Compliance Assessment Report CAR_NRW0037675

Permit being assessed: AB3690CP.

For: J M Envirofuels (Barry) Limited, held by JM ENVIROFUELS (BARRY) LIMITED

At: Berth 31 Wimbourne Rd, Barry Docks, Barry, CF63 3DH.

Duty of Care Transfer Notes

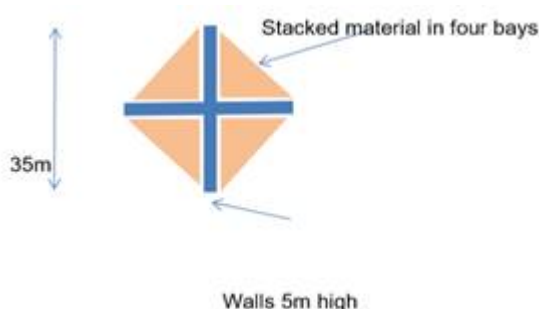
Officer Gillian Coates reviewed a sample of weighbridge tickets on site and was provided with a printout for unprocessed wood waste removed from site between 14/01/2021 and 29/01/2021. However, the notice required the operator to provide evidence in the form of Duty of Care Transfer Notes to prove that the waste stored for more than 3 months had been removed to a permitted facility.

REQUIRED: Please provide Duty of Care Transfer Notes as evidence of the waste transfer to a permitted facility, for the wood waste stored for more than 3 months by the 15th March 2021 (as per the requirement of the notice).
